Re: Los Gatos North Forty; Request for Modification (S-20-012) to an Existing  
Architecture and Site Application Approval (S-13-090)

SummerHill Responses to Letter from Barbara Dodson:  
Responses Provided in Red Text

**SUBJECT: ELIMINATION OF THE UNDERGROUND GARAGE IN THE NORTH FORTY**

PLAN FOR THE IMPROVEMENT OF  
**LOS GATOS NORTH 40 - PHASE 1**  
**COMMERCIAL**  
**PARKING SPACES**

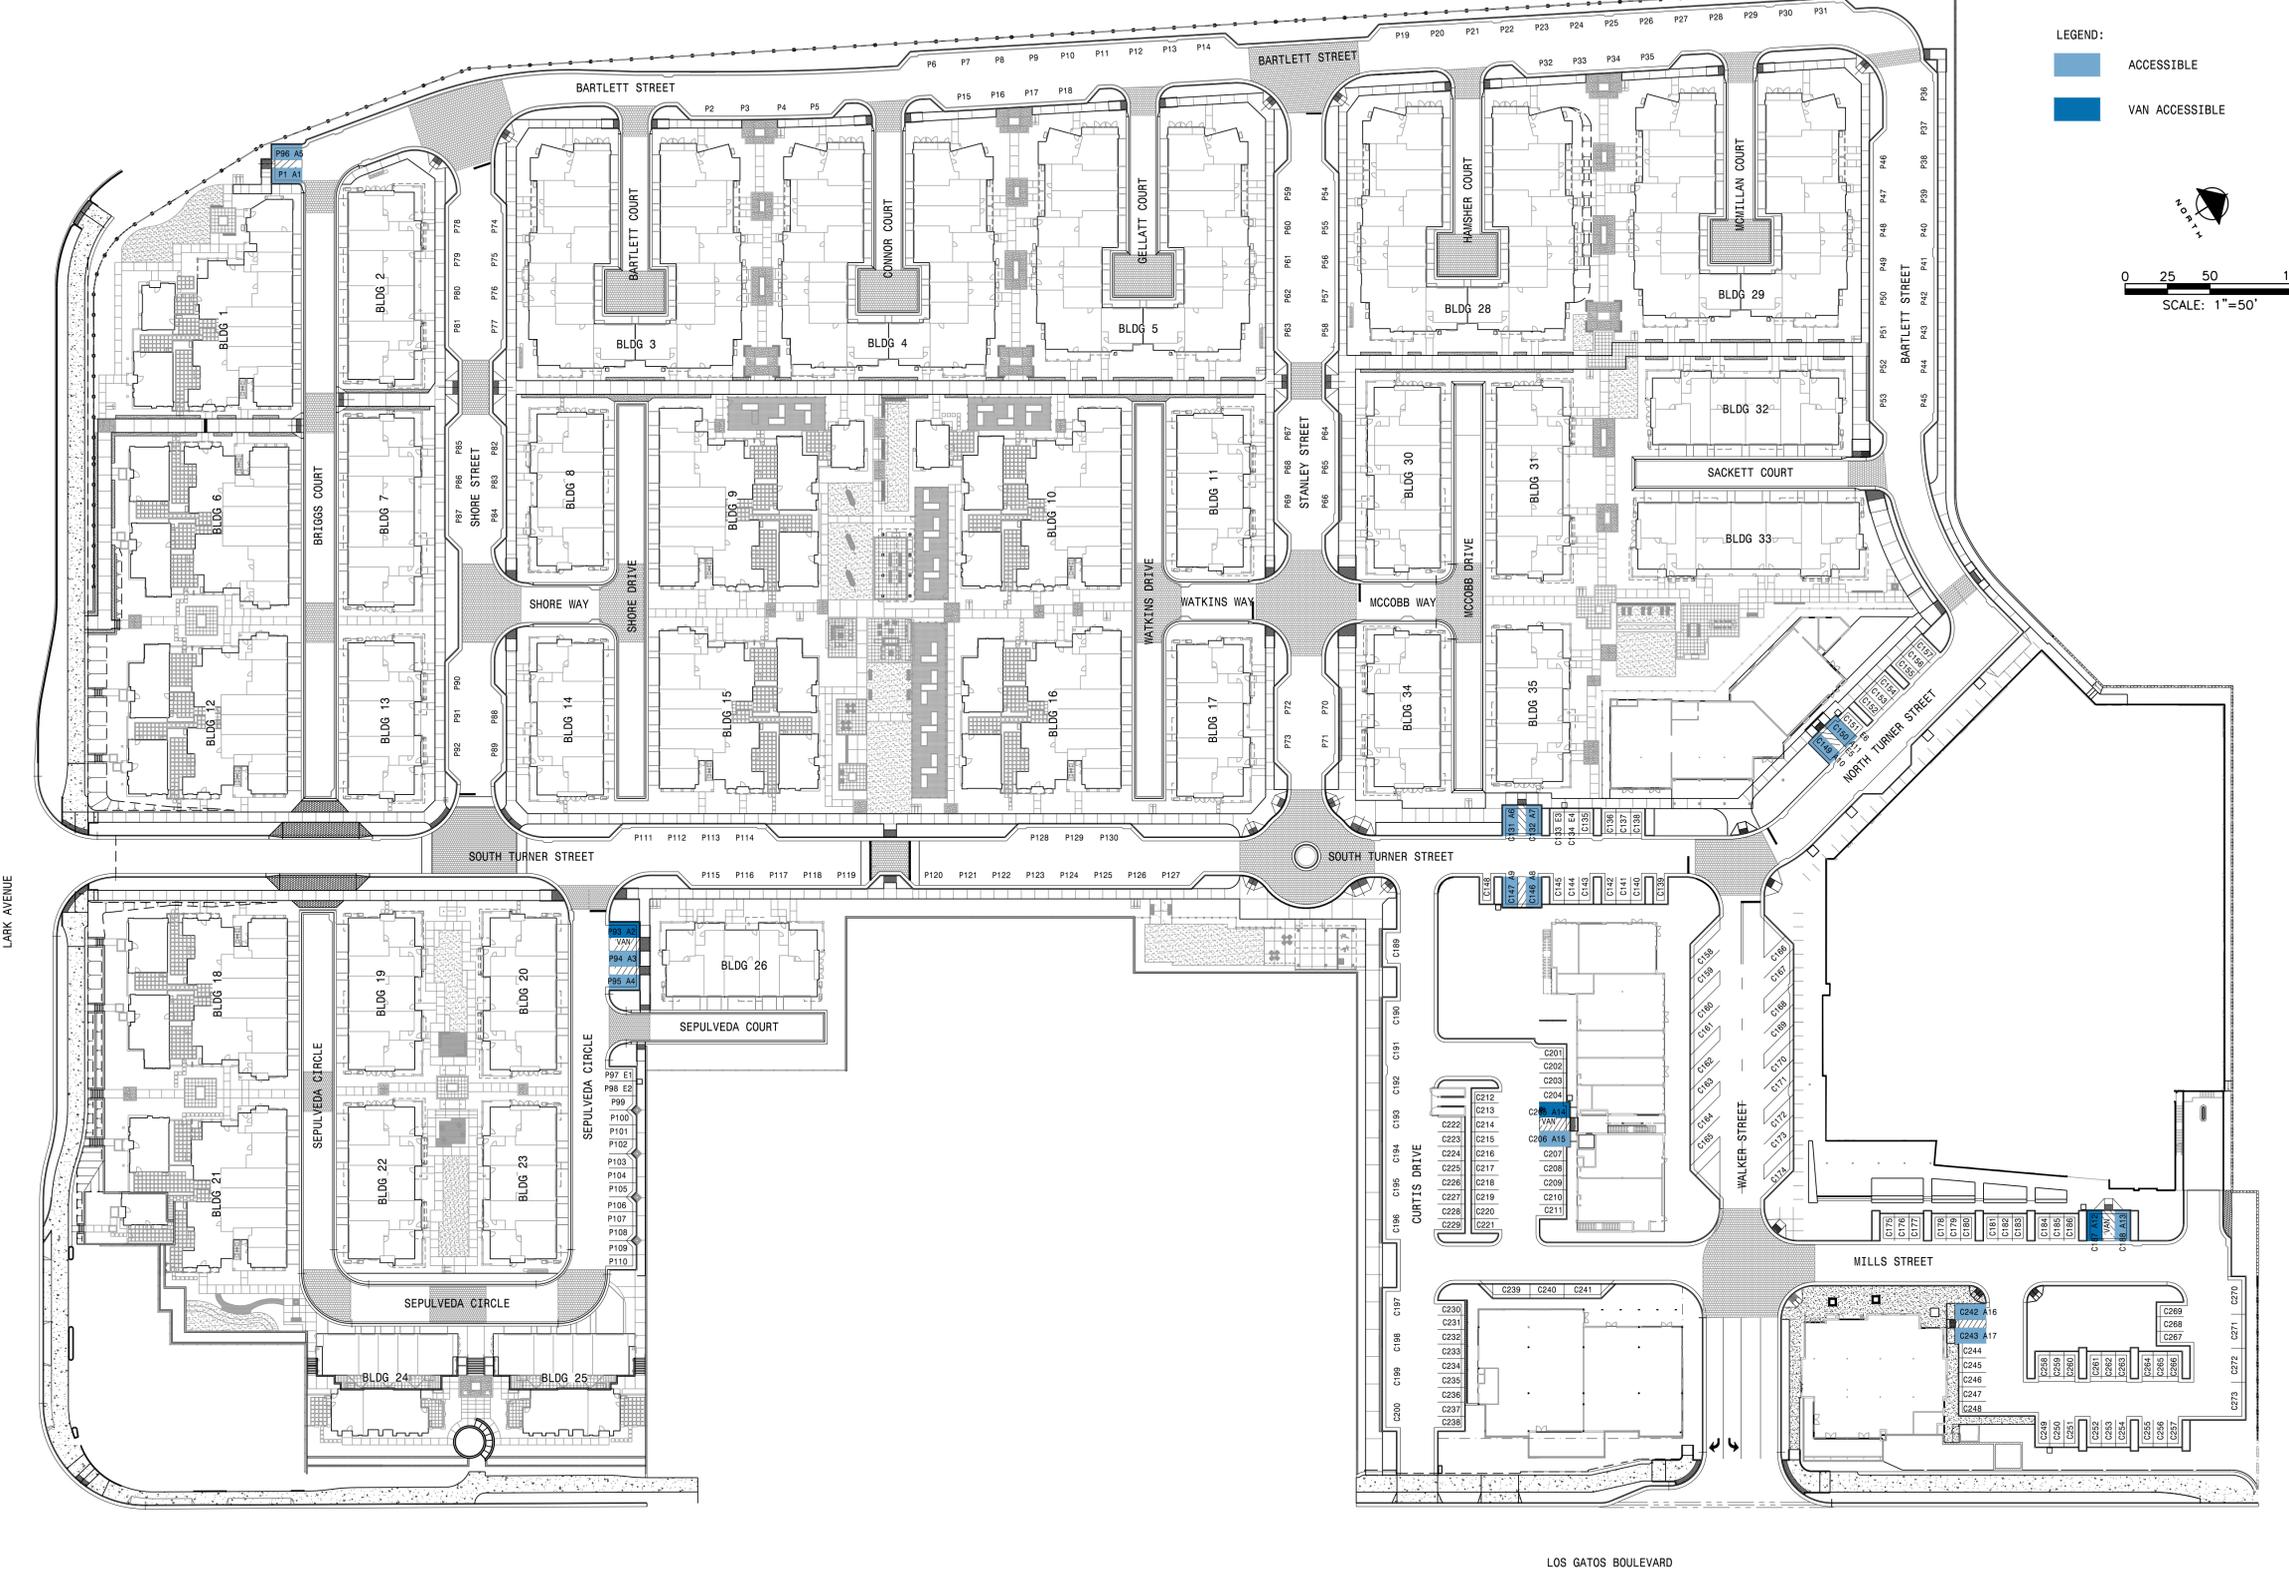
In addition, at Staffs request we have provided a summary of the residential square footage totals for the project, a table of the parking proposed and required for the residential portion of Phase I within the Lark District and Transition District D, and a site plan with a count of all of the surface parking currently proposed for Phase I.
